SERVICE BULLETIN

SB08-1

SUBJECT: ROCKER SHAFT INSPECTION AND REPLACEMENT

PURPOSE: To provide instructions for the inspection of P/N 653816 and subsequent cylinder assemblies for the installation of the P/N 654375 rocker shaft and to provide replacement instructions for any P/N 654375 rocker shafts found installed.

FIGURE 1
P/N 654375 ROCKER SHAFT INSTALLATION
(ROCKER ARMS REMOVED FOR CLARITY)

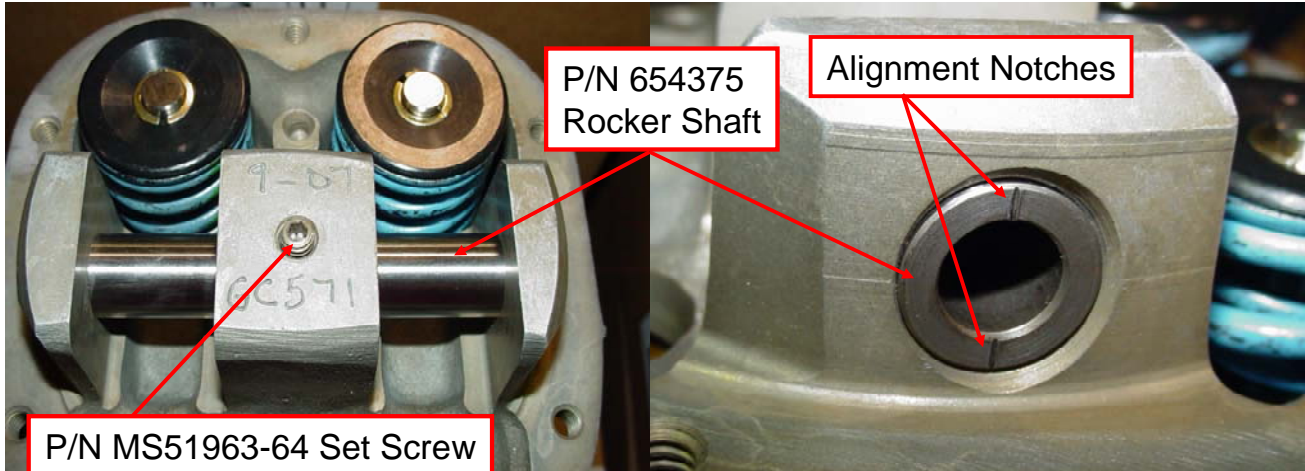
- 1) Using the airframe manufacturers maintenance instructions remove the engine cowlings and engine cooling baffles as necessary to access the cylinder rocker covers.
- 2) Remove the rocker cover from each cylinder.
- 3) Inspect each cylinder for the presence of the P/N 654375 Rocker Shaft and the P/N MS51963-64 Rocker Shaft Retaining Screw. (Reference Figure 1 and Figure 2) If the P/N 654375 Rocker Shaft is not installed, no further action is required. Go to step 6.

- 4) If the P/N 654375 Rocker Shaft is installed proceed as follows:
 - a) Rotate the engine to bring the piston to top dead center. Both valves will be closed.
 - b) Remove and discard the P/N MS51963-64 Rocker Shaft Retaining screw.
 - c) Remove the P/N 654375 Rocker Shaft and retain for return to TCM.
 - d) Reinstall the rocker arms utilizing a new P/N 21153 Rocker Shaft.

FIGURE 2
P/N 21153 ROCKER SHAFT INSTALLATION
(ROCKER ARMS REMOVED FOR ILLUSTRATION)

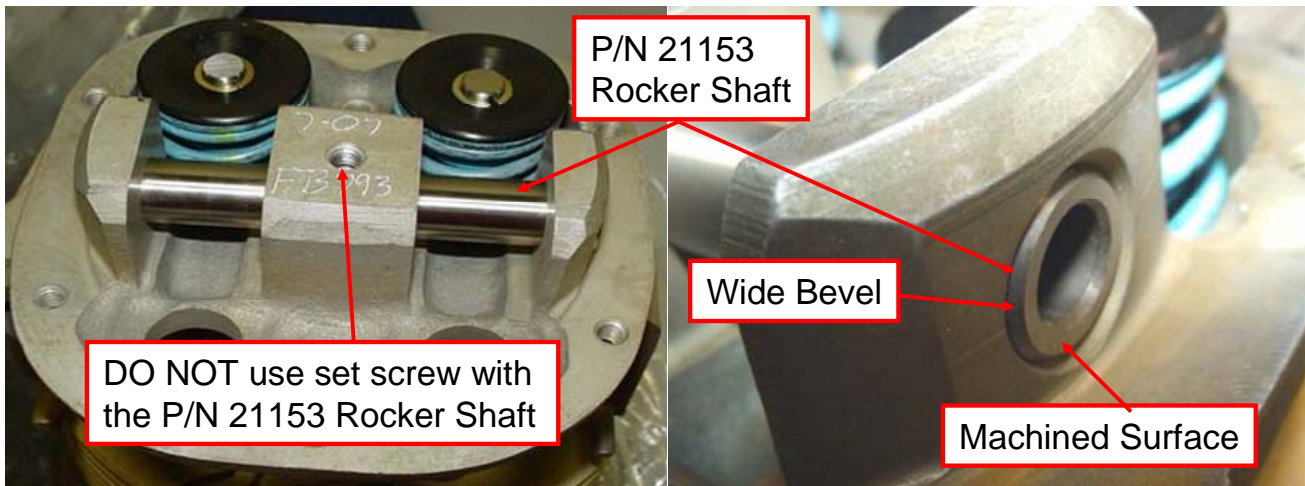
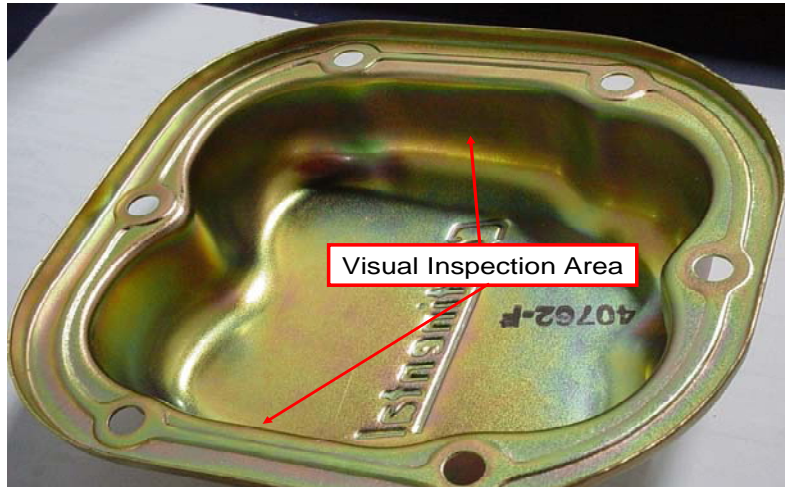
The P/N MS51963-64 Rocker Shaft Set Screw MUST NOT be used with the P/N 21153 Rocker Shaft.

**FIGURE 3
ROCKER COVER INSPECTION**

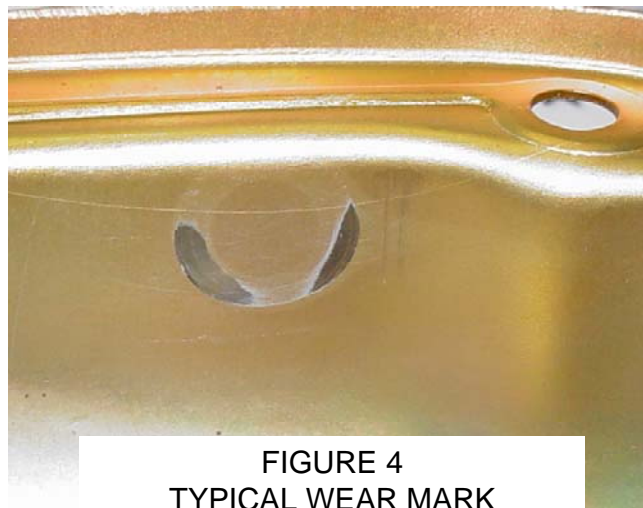
- 5) If the P/N 654375 Rocker Shaft was installed, inspect each Rocker Cover for chafing in the areas as indicated in Figure 3. If damage in the form of metal removal is found, the Rocker Cover must be replaced with a new P/N 40762 Rocker Cover. Acceptable wear pattern is shown in Figure 4.
